Summary of BT mechanics review

Eugenio Berti, Raffaello D'Alessandro, Sebastiano Detti, Lorenzo Pacini, Oleksandr Starodubtsev, for the Firenze INFN HERD group.

Starting design (Monday. 19/04)

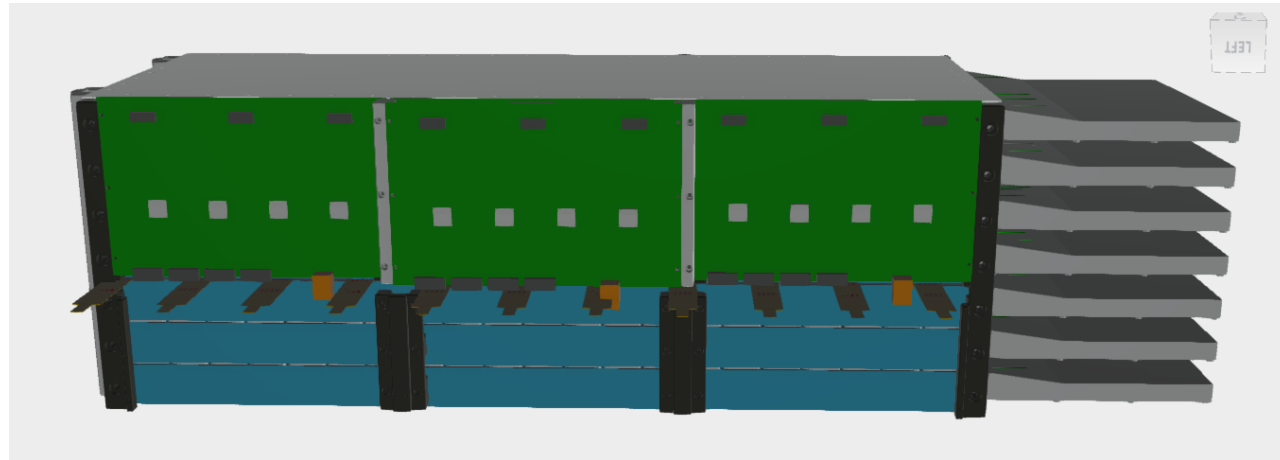
Error regarding: hole orientation, cable configurations, HIDRA board directions....

Current design

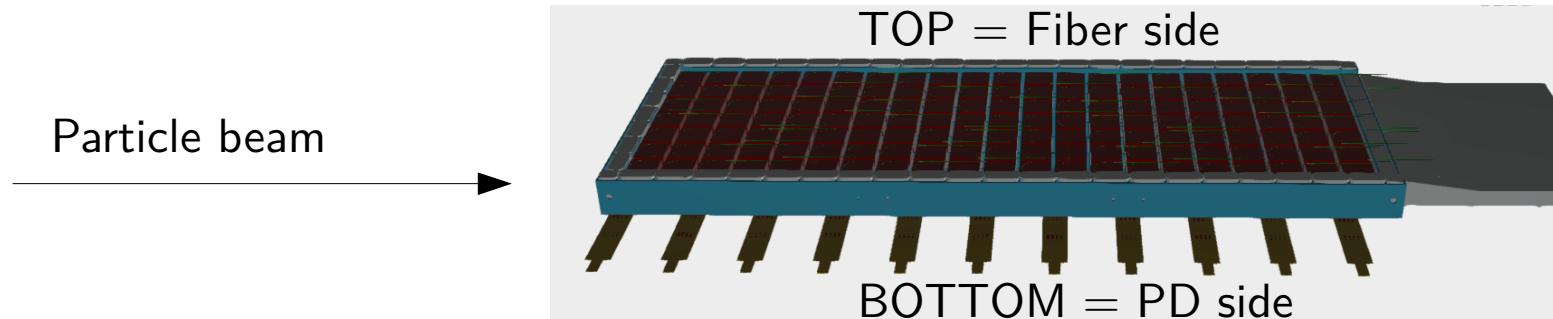
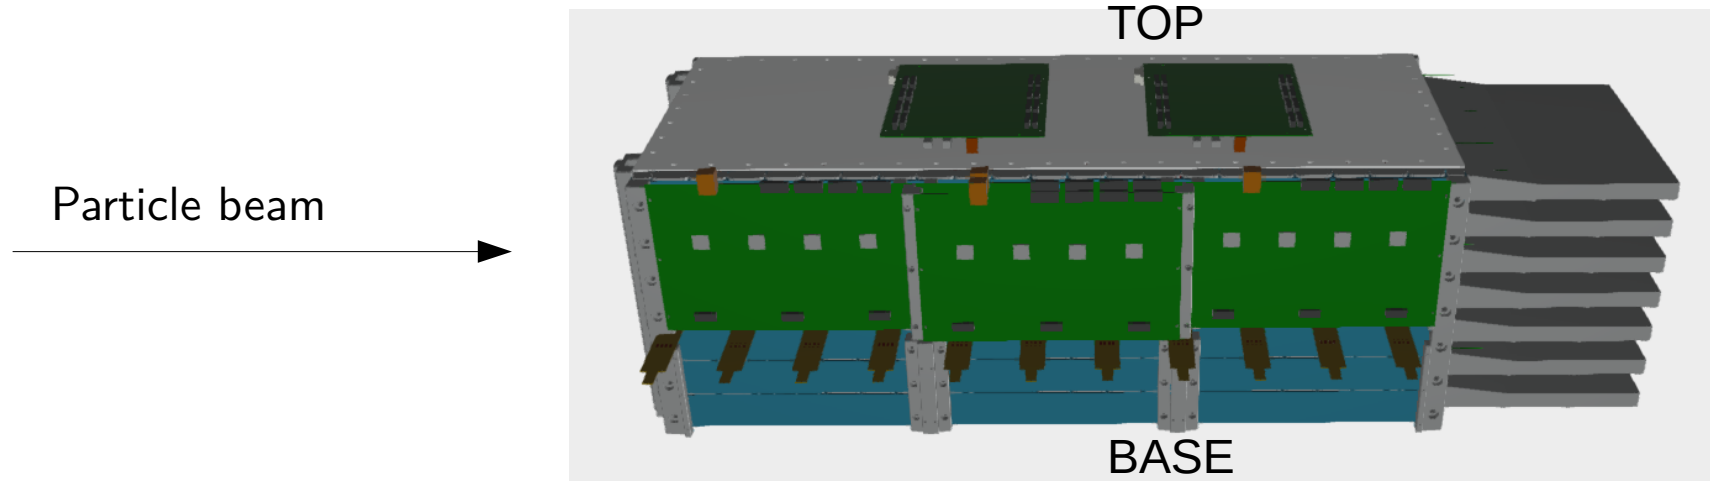
After 2 iterations of correction: the final version adjusted by Olek (to be accepted by IEHP)

Check layer holes

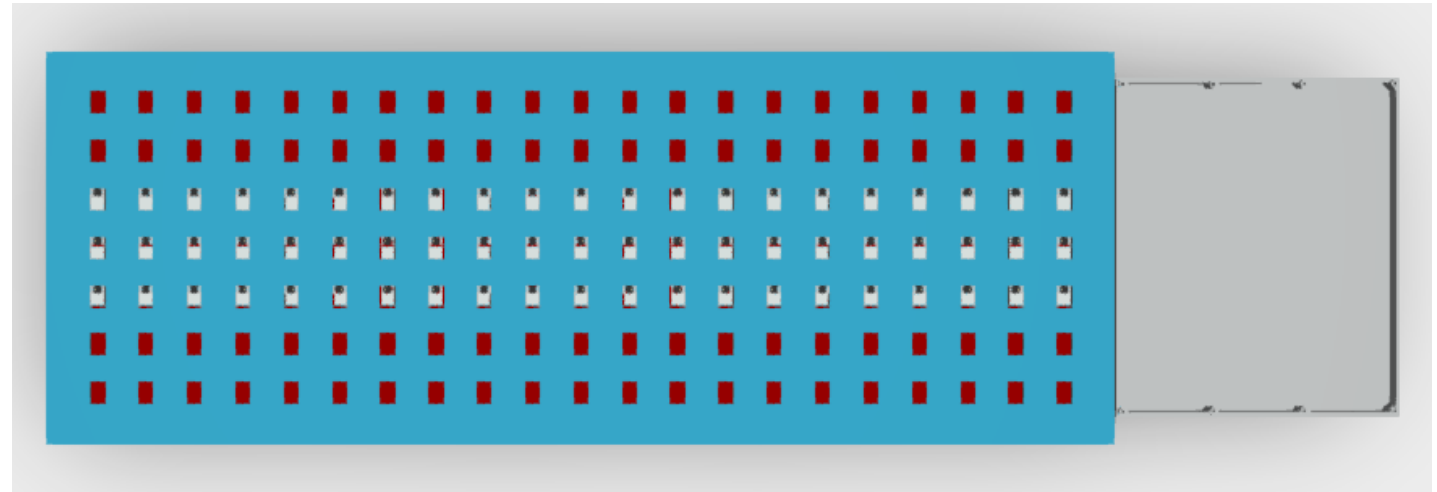
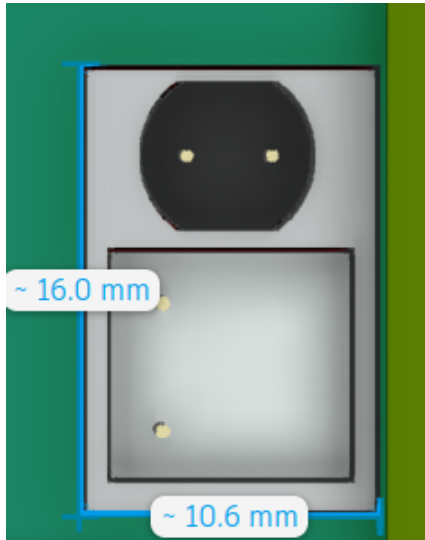
Holes position and direction: OK

Holes dimension (16*10.6): OK

Cable position: current design

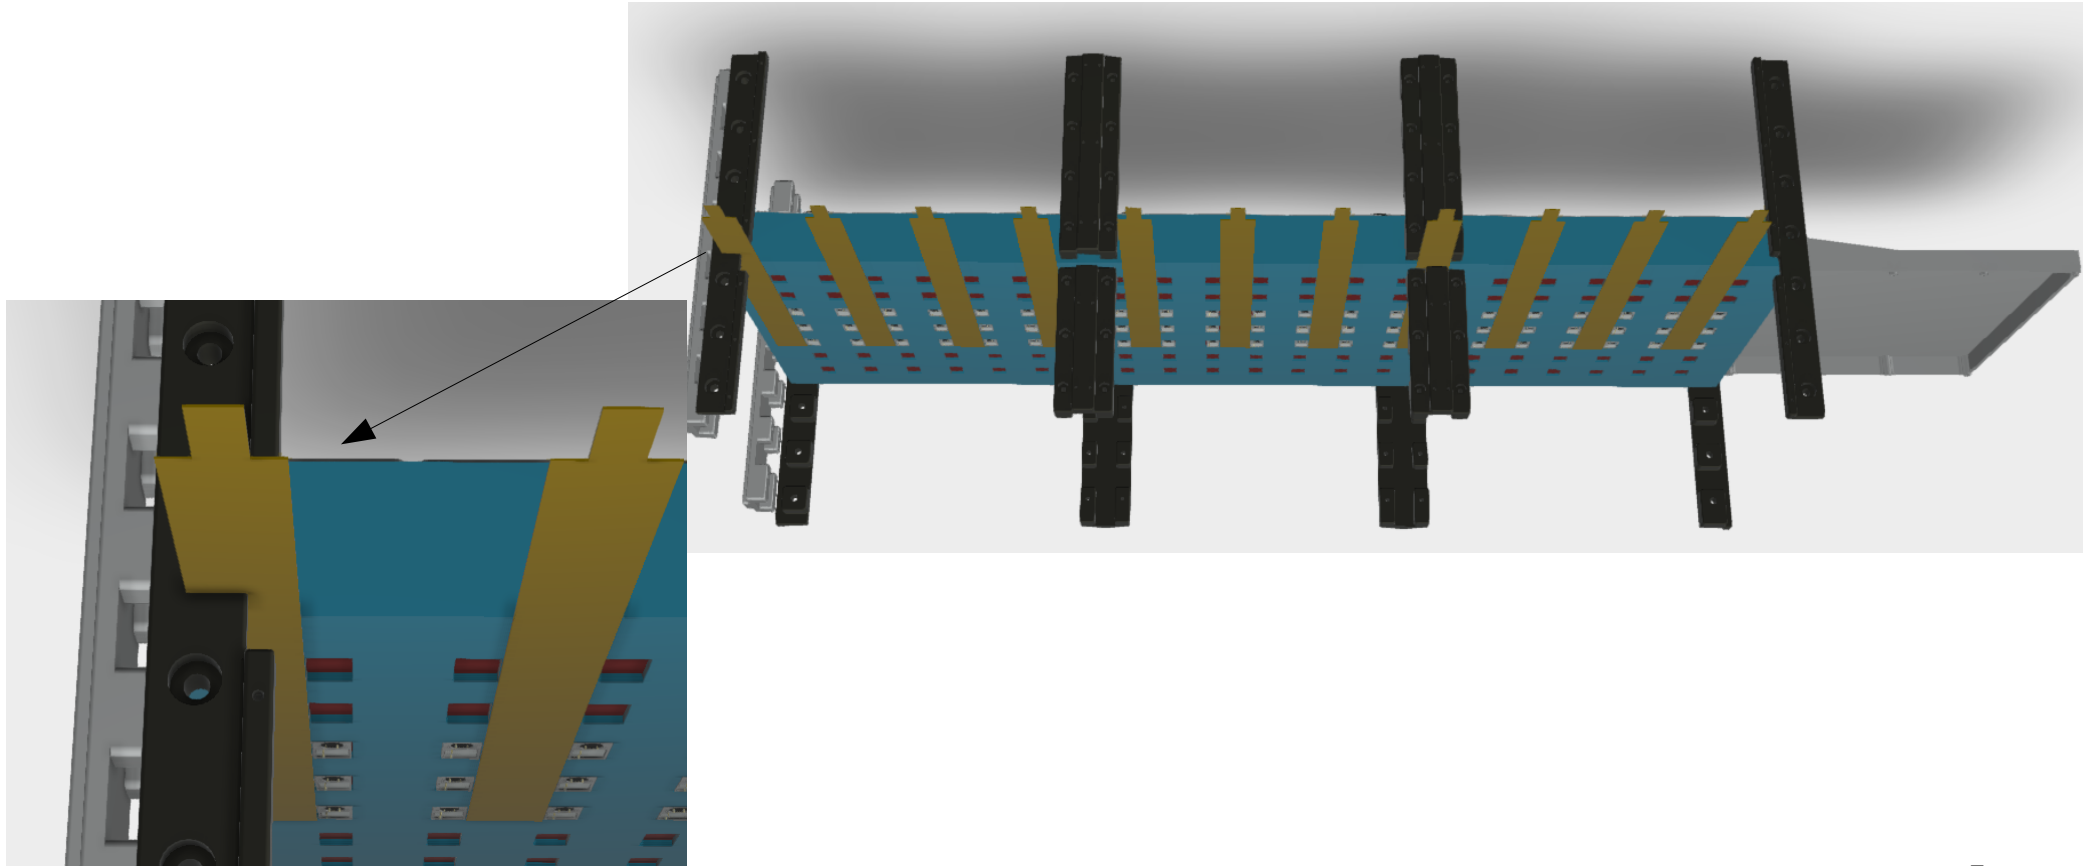
In this design the first cable hits a mechanical structure:

Electronics: TROC1-2 position

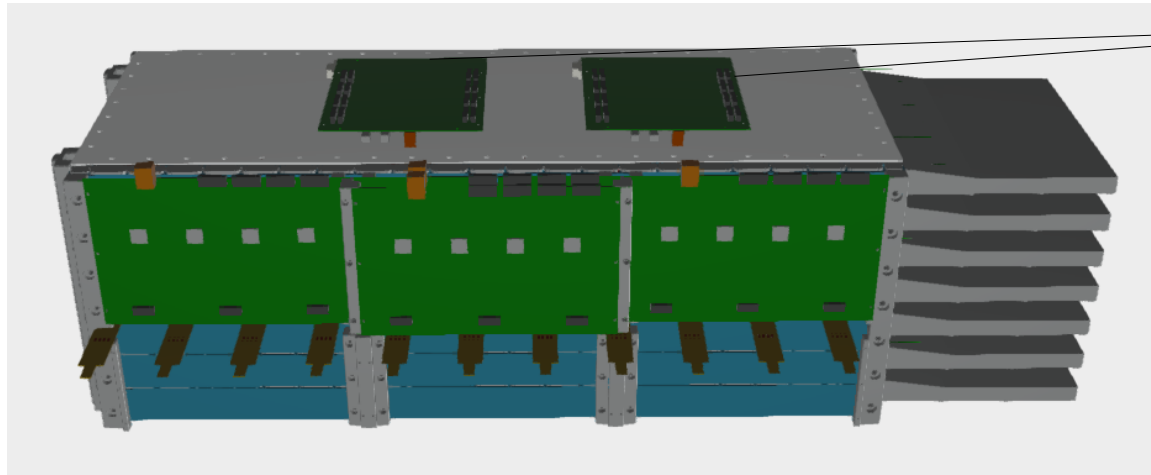
Our proposal is to place 2 TROC2s on the top, one is enough but two are better for connecting with HIDRA boards.

TROC1 is placed outside the large box; it must have a hole for cables: 6 Ethernet cables, 2 power cables (one for TROC2 and one for HIDRA) and 1 cable for PD bias.

“Flight” design: side detectors, top view

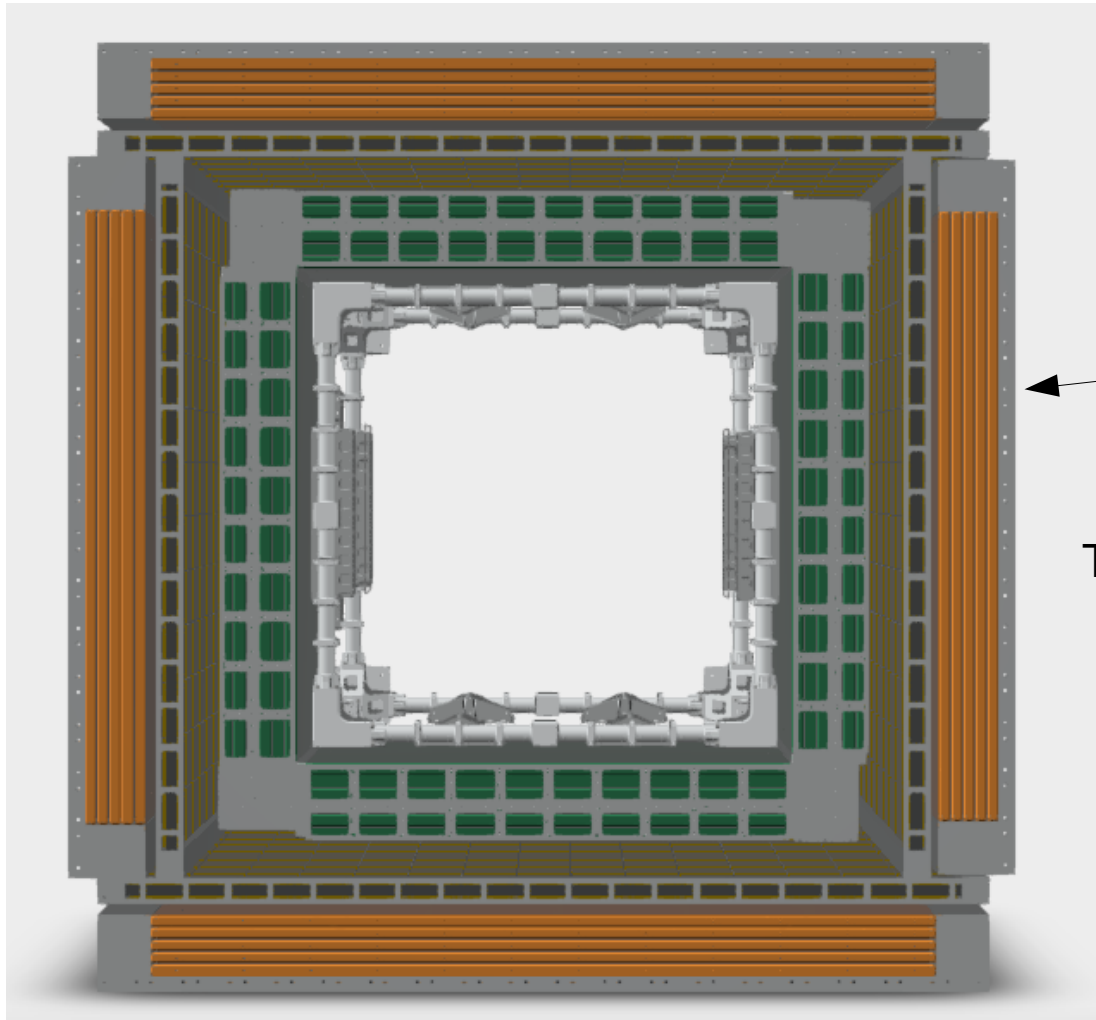
I found a mistake in the name of a volume:

PSD-side-s_MIR1:1 is this SCD detector

This face is named “FRONT”
